STATION HILL READING

AMENDMENTS TO RMA REF:
201537/REM PLOT E

NMA 08

Architectural Statement

1 Site - Friars Street Elevation Plot E
1:250

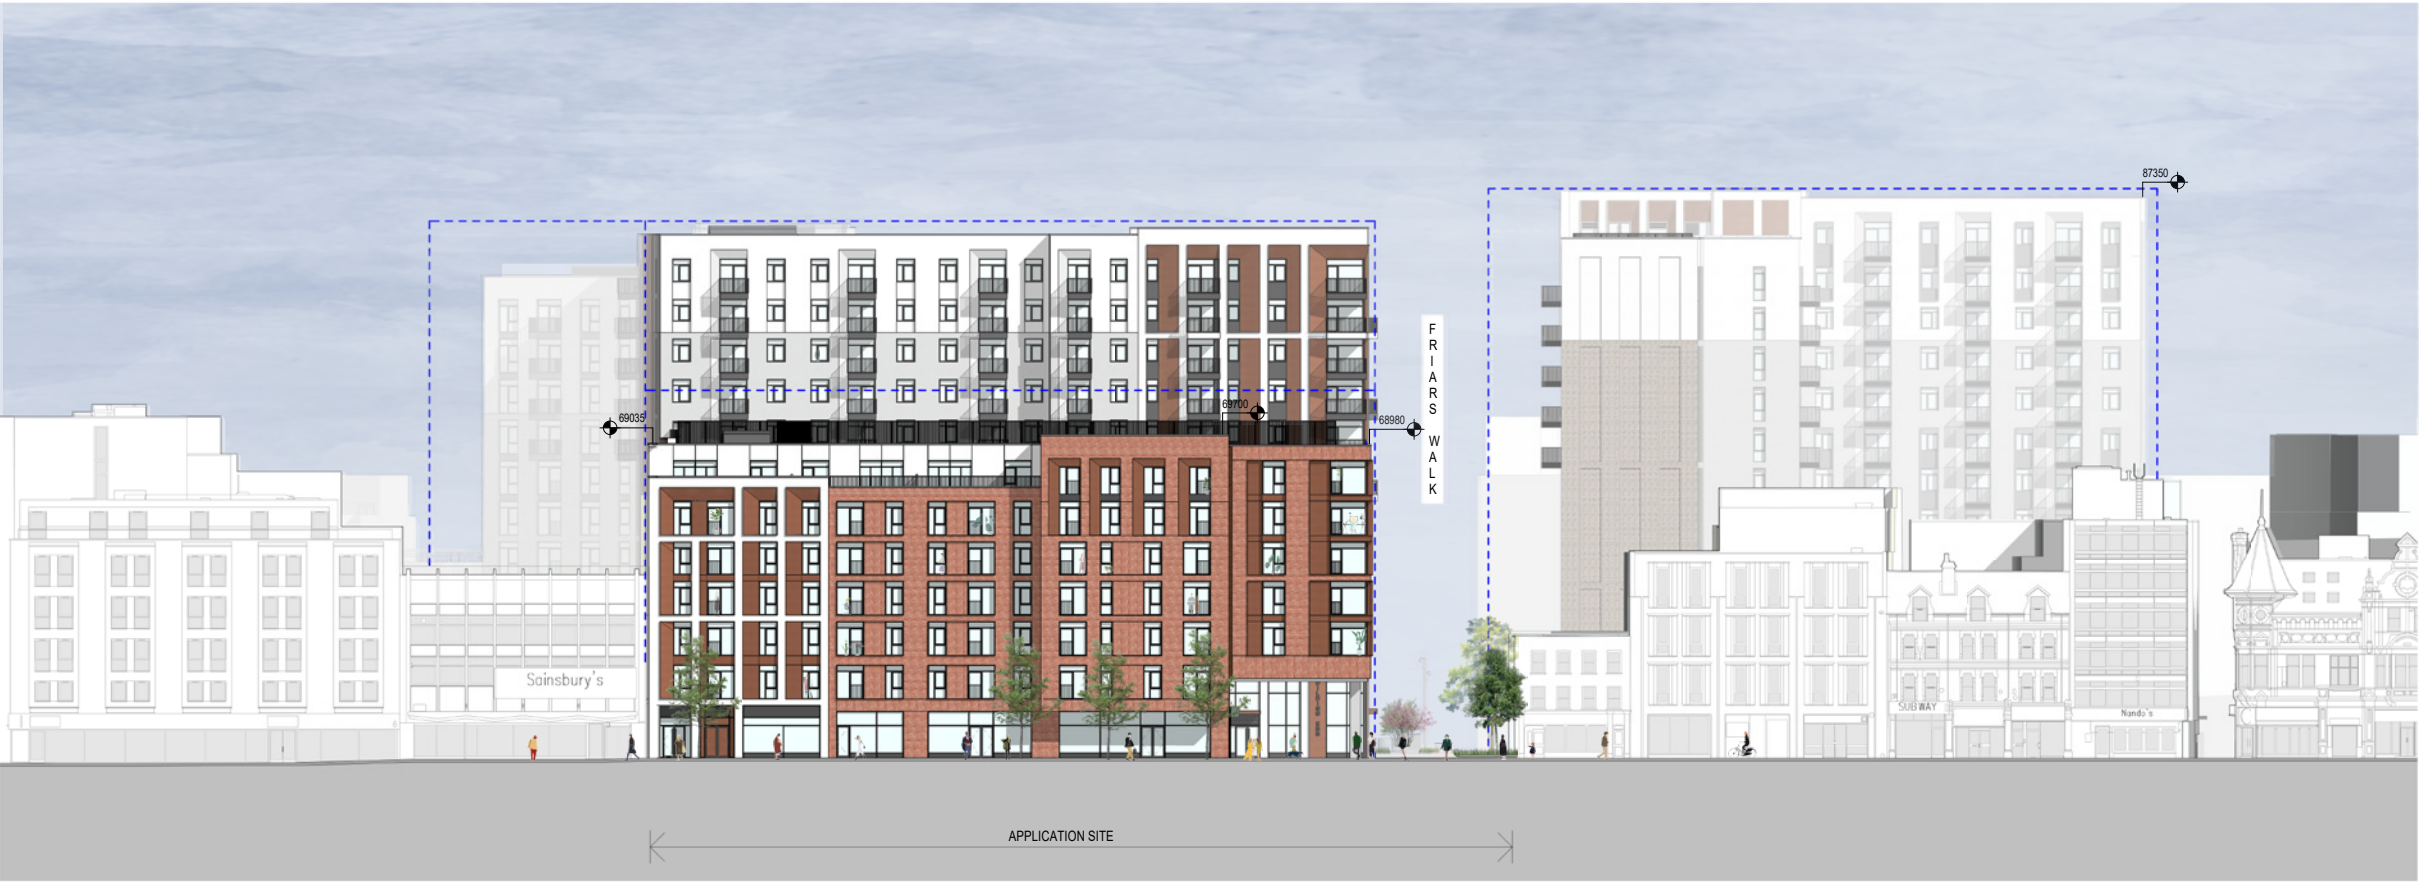
01 No base build changes - advertisement application to follow

02 Aluminium panel to be replaced with Z profile louvres, metal with RAL to match curtain wall framing
